# CITY OF ALBUQUERQUE

**Re: 8015 Victoria Dr. NW**  
**Request Permanent C.O. - Denied**  
**Engineer's Stamp dated: 11-20-19 (E10D038)**  
**Pad Certification dated: Not submitted**  
**CO Certification Date: 2/10/2021**

Lots 13, Block 6  
Volcano Cliffs Subdivision, Unit 5  
GRADING PLAN

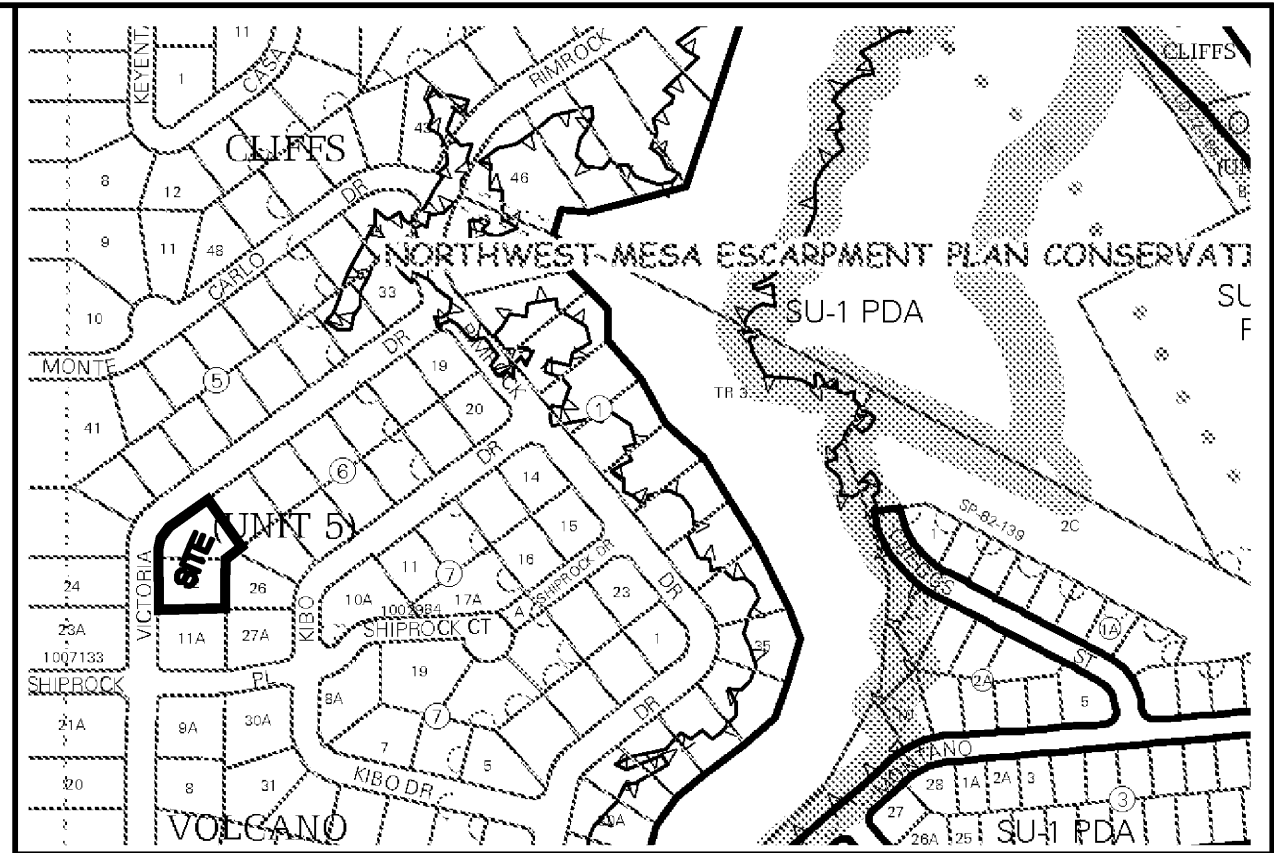
- A pad Certification is required.
- Provide a berm or some type of wall to prevent flows from entering the lot at the NE corner. Picture provided below
